From: Mess, Camie
Sent: Wednesday, April 25, 2018 5:41 PM
To: bart.mcinotosh@cbre-charlottesville.com
Cc: Werner, Jeffrey B
Subject: BAR Actions - April 17, 2018 - 300 East Main Street

BAR 18-04-03
300 East Main Street
Tax Parcel 280040000
East Main Investments, LLC, Owner/Bart McIntosh, Applicant
Window replacement

**CITY OF CHARLOTTESVILLE
BOARD OF ARCHITECTURAL REVIEW
STAFF REPORT
April 17, 2018**

Window replacement

DOWNTOWN BANK

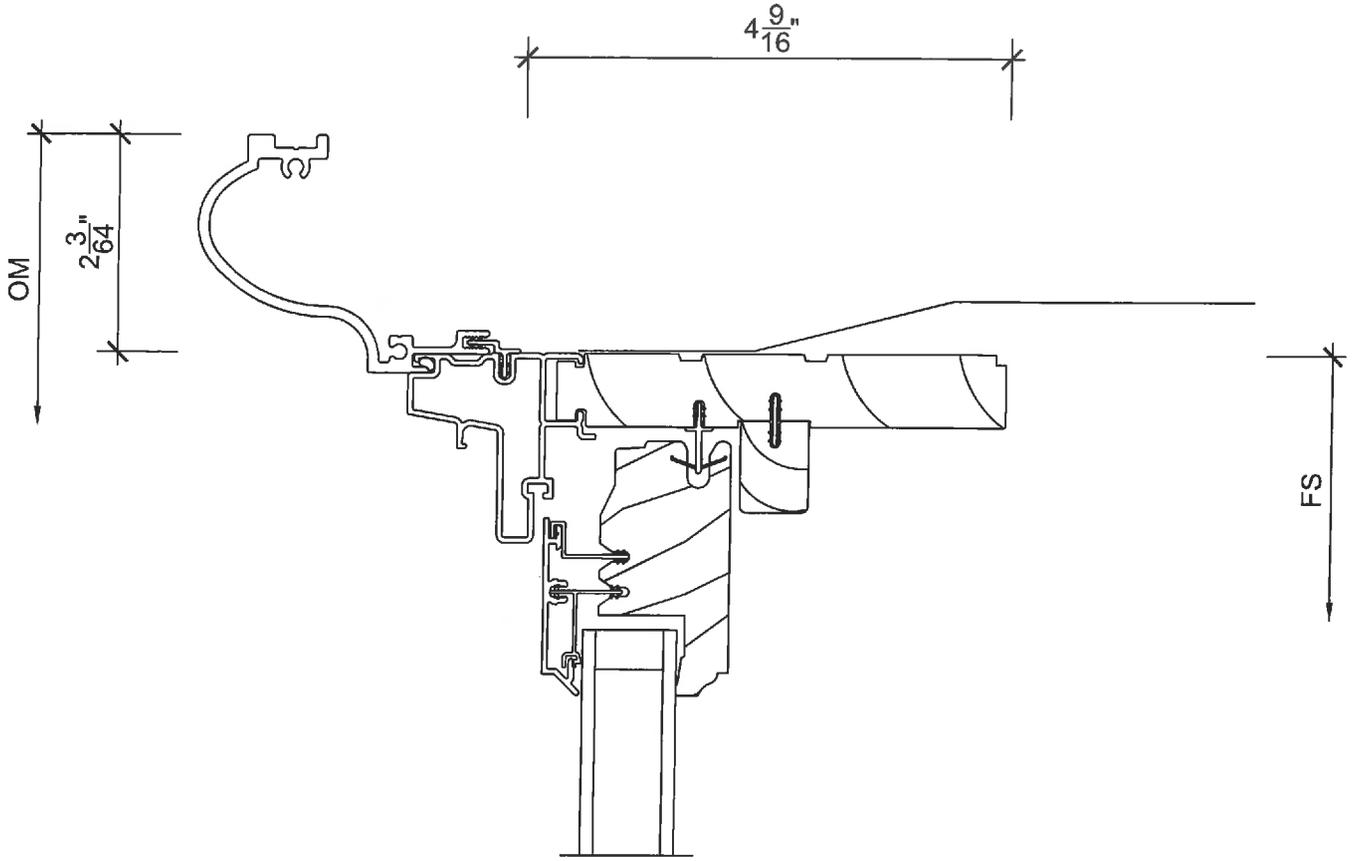
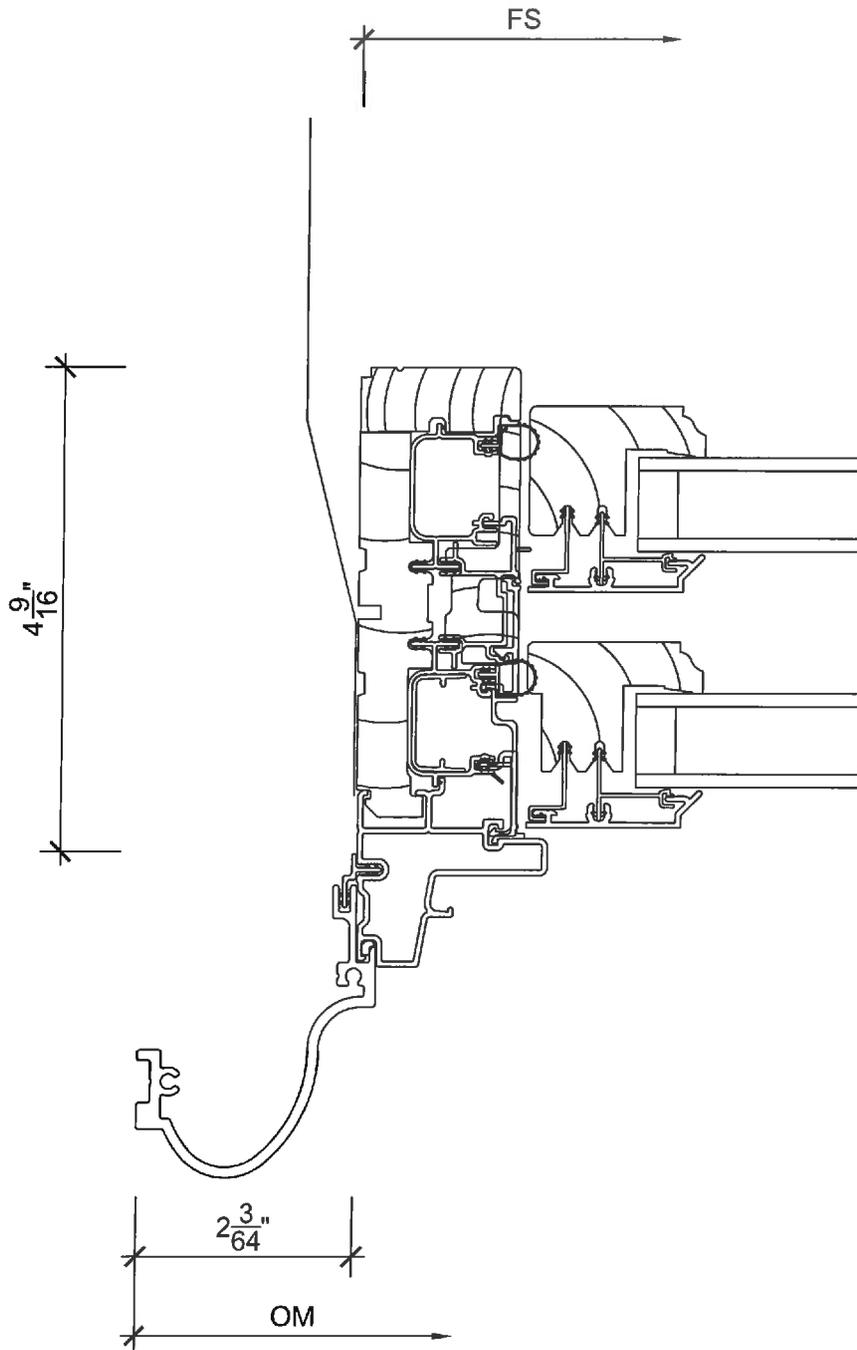
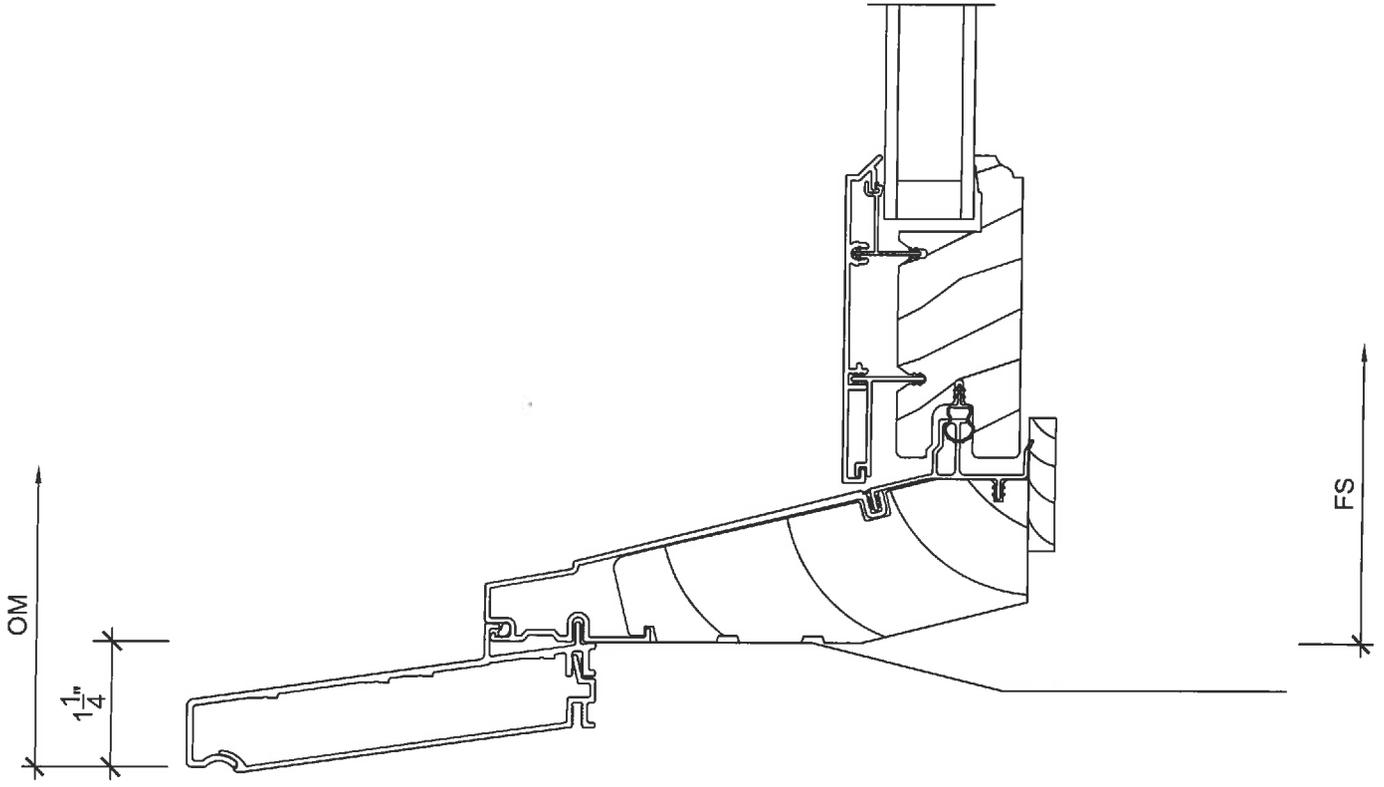
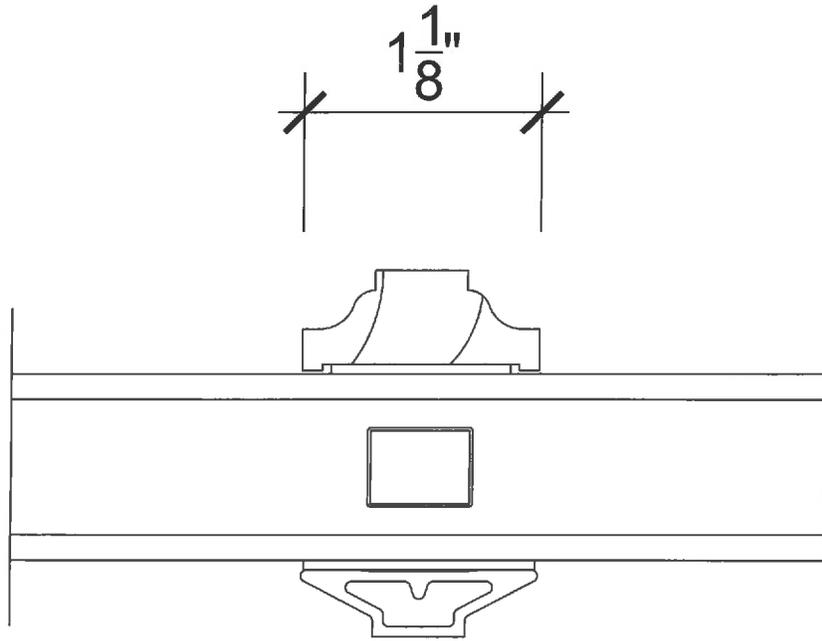
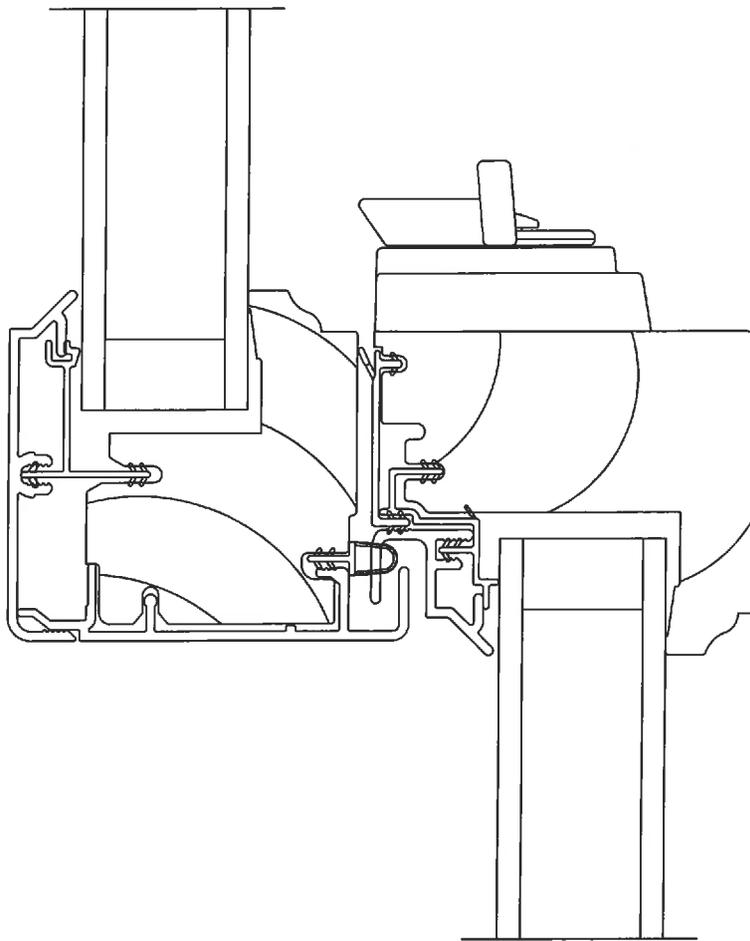
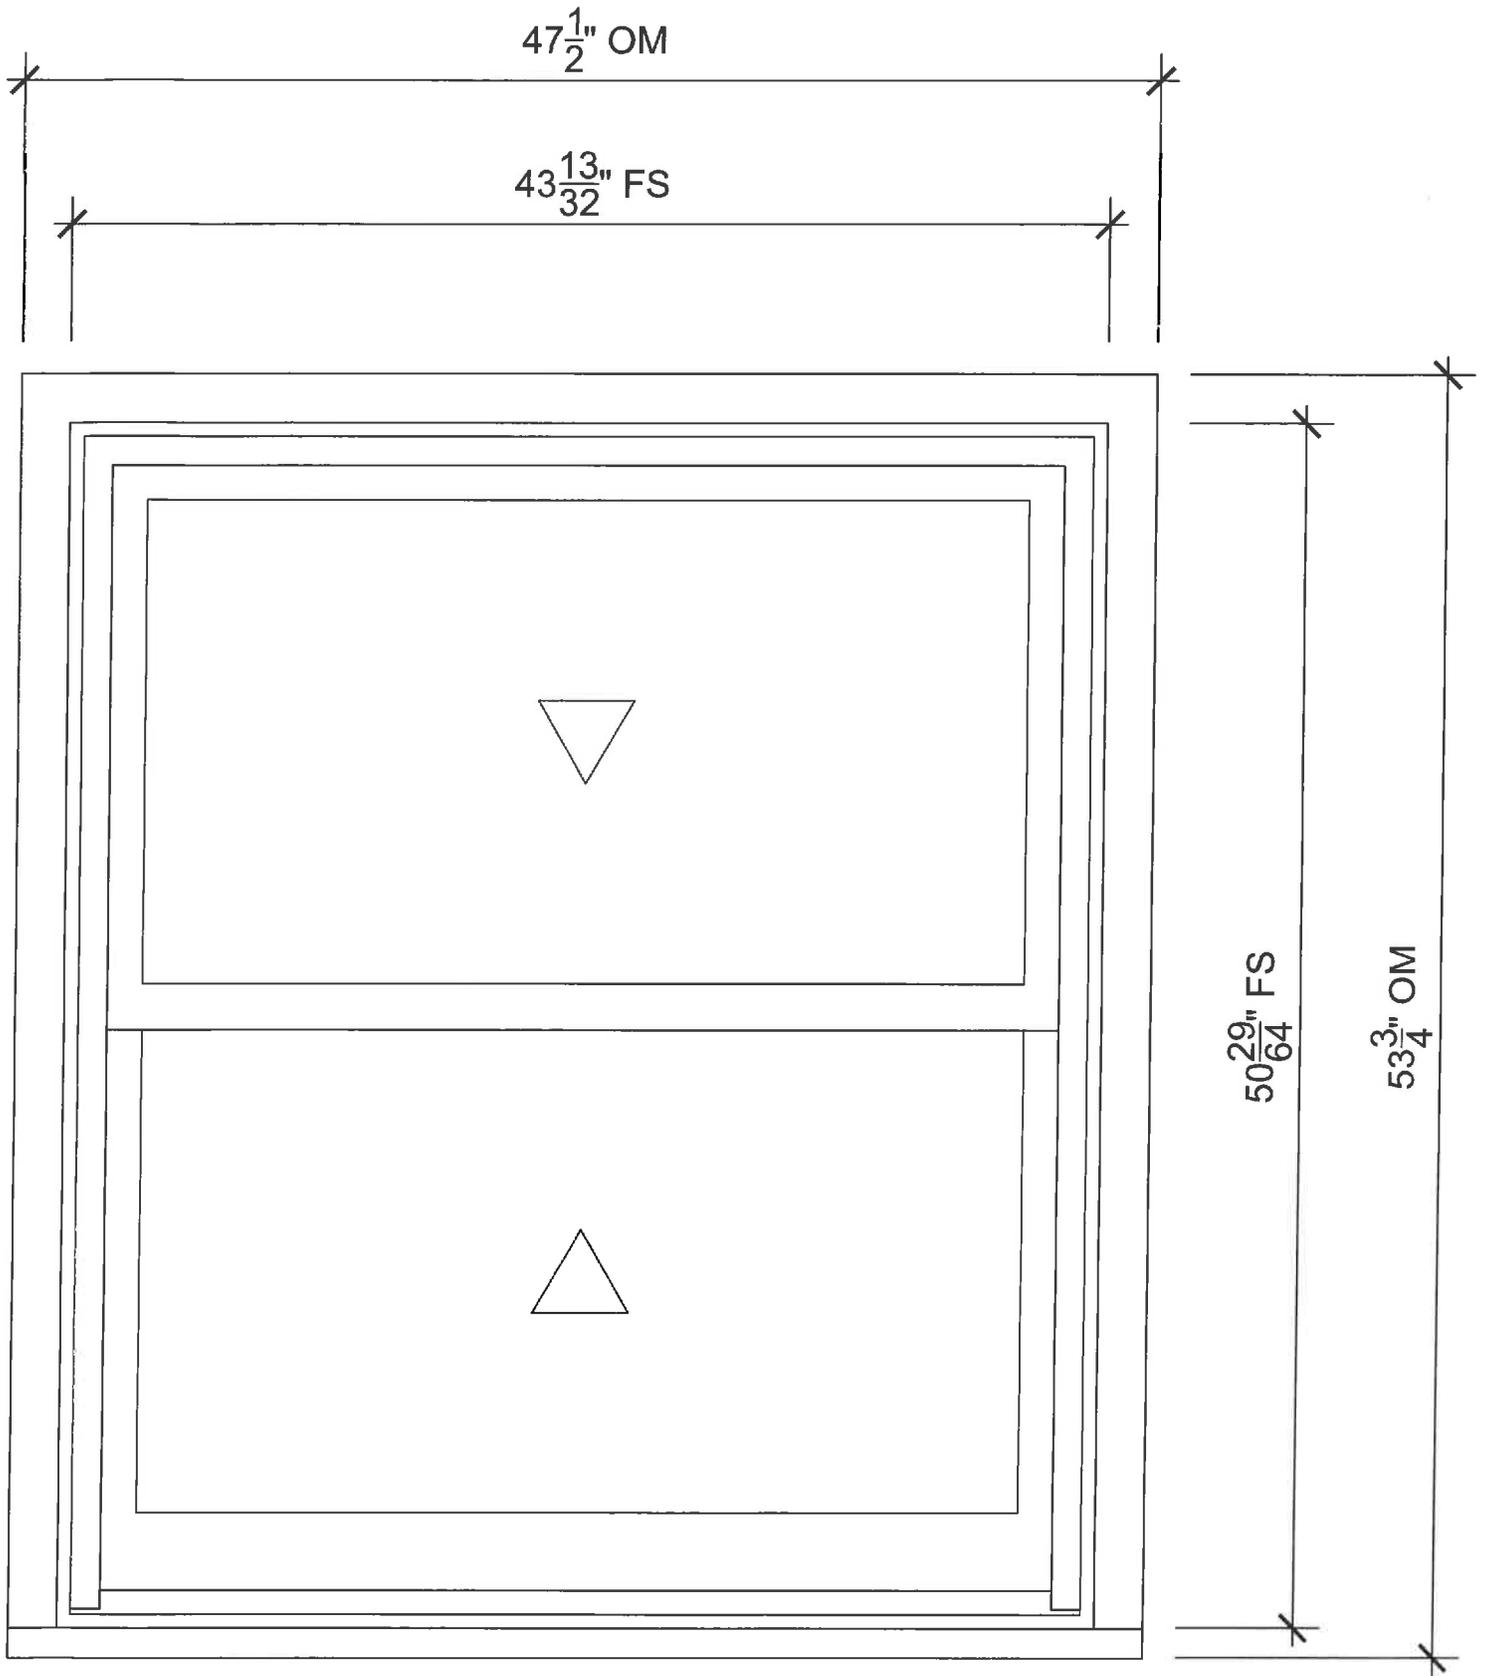
- **Provide a flashing detail at sill and head**
- **Provide an inventory/survey of the current condition of each window (explain need for replacement)**
- **BAR prefers rehabilitation of the existing windows**
- **Recommend addressing all the windows of this type, at this specific location-- not just five (Note: There are seven street level openings, but only 6 with windows.)**
- **Existing steel window bars [painted green] to remain**

For the Marvin windows: top rail of the upper sash is 1-7/16" (close to the existing); the stiles are 1-15/32" (close to the existing); the lower sash bottom rail is 3-1/4" (larger than the existing). The jamb and sill face dimensions are larger than the existing and the bullnose trim is significantly different in shape and size. And the Marvins are clad, not painted wood.
